service bulletin

No. 94-5

A. Drive Unit Trim Tab / New Anodic Plate

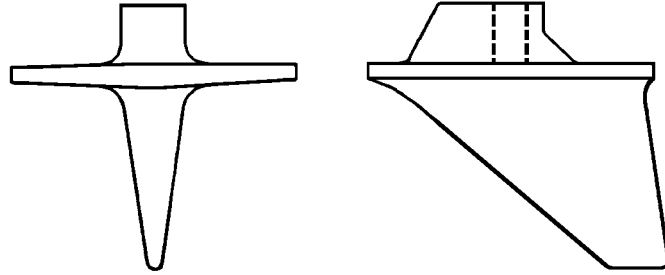
The Zinc Trim Tab with the fin has been replaced with a new style (flat plate) type Aluminum Anode on all 1.50:1 / 1.65:1 and 1.84:1 Alpha One Generation II and Bravo One / Two and Three drives.

The only drives that will have a Trim Tab with a fin will be the **1.98:1** and the **2.40:1**. These drives are used with the 3.0L that does not have power steering and may require a Trim Tab to help Correct steering torque, It will also be used on the 3.0LX package which has power steering.

The Trim Tab used on the 3.0L is made from Aluminum, there will be no more Zinc Anodes used on MerCruiser Product.
